ADDENDUM No. 1

May 8, 2019

Subject: Village of Antioch 2019 Resurfacing Program
Section Number: 20-00000-01-GM
May 14, 2019 Letting

**VILLAGE OF
 ANTIOCH
 2019 ROAD PROGRAM**

EXISTING TYPICAL SECTION

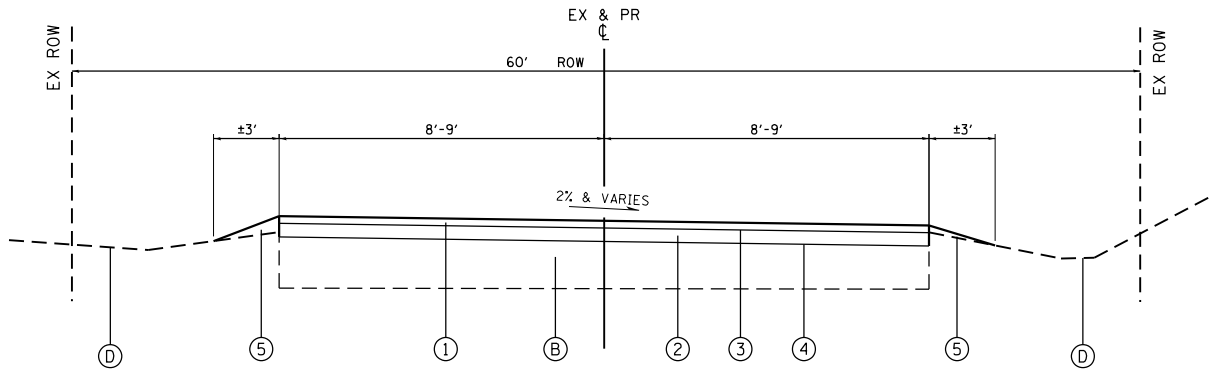
1. The project Typical Sections have been revised to include Pulverization, 8 Inch on Little Windsor Drive, therefore
 - **Add the enclosed "Typical Section 2B" to the original proposal booklet.**
